LSST Pixel Coordinate Definitions

Appendix: Physical layout of CCD segments

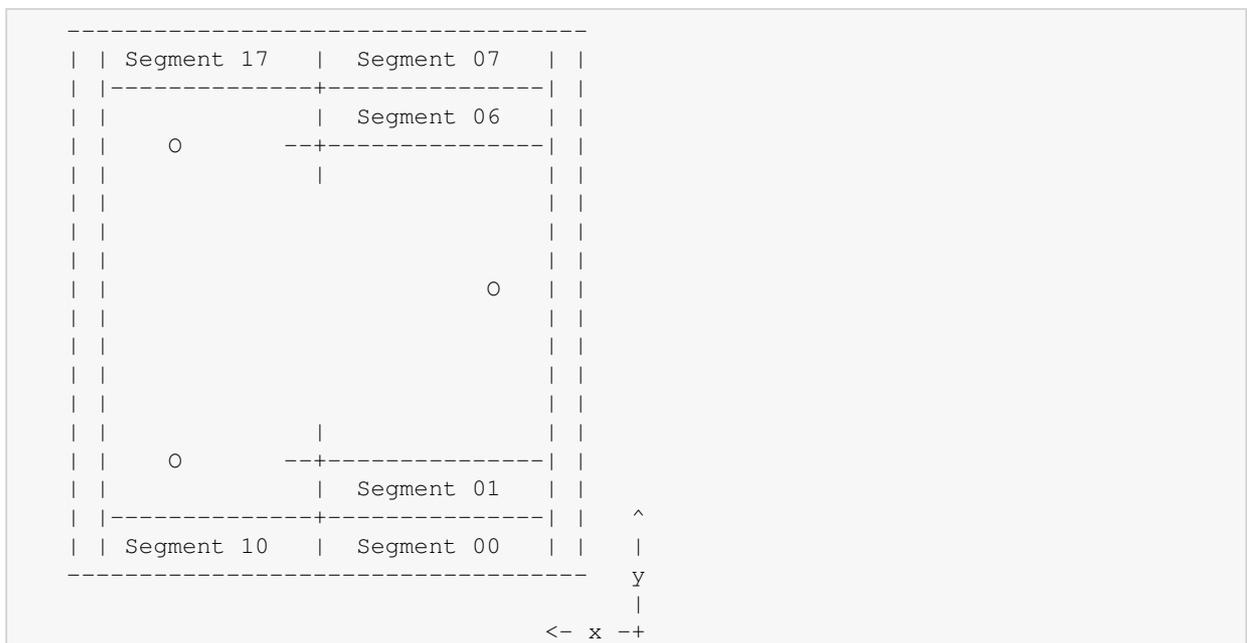
I'm a bit concerned about the "non-smoothness" of the mapping in the third "Note" above. Why is the coordinate system CCD-based and not amplifier-based (which would presumably be at least closer to "smooth"? For that matter (acting as devil's advocate), why is it not FOV-based? I can imagine that for some ISR computations there will be a need to work with physical image-plane coordinates; which pixel coordinates provide the simplest mapping for this?

It seems strange to use a convention that is based on the whole CCD rather than the amplifier, yet does not have a smooth translation between pixel position and x,y position on the CCD. I can see alternatives:

- Use the amplifier-based convention: the pixel with index (0,0) is the first pixel read out. Then a full CCD image is a mosaic of amplifier images, each with its own WCS. I believe this is the conventional approach. This approach has the advantage that it is easy to handle overscan in the ISR pipeline, and it will simplify handling data from other surveys.

- Specify the position of the lower left corner of the CCD as (0.0,0.0), but increase pixel position linearly with actual physical position of the CCD. Thus the center position of pixels on the next amplifier will probably not end in .0. One will have to use a function to translate pixel index to pixel position (which I have long advocated) but the offset to this function will be stored in the metadata for each amplifier image (rather than being a project-wide constant), and a lookup table for this for a full CCD image. I suspect this proposal and the original proposal both will have very similar headaches if one is trying to process an entire CCD image at once (if the algorithm cares about position).
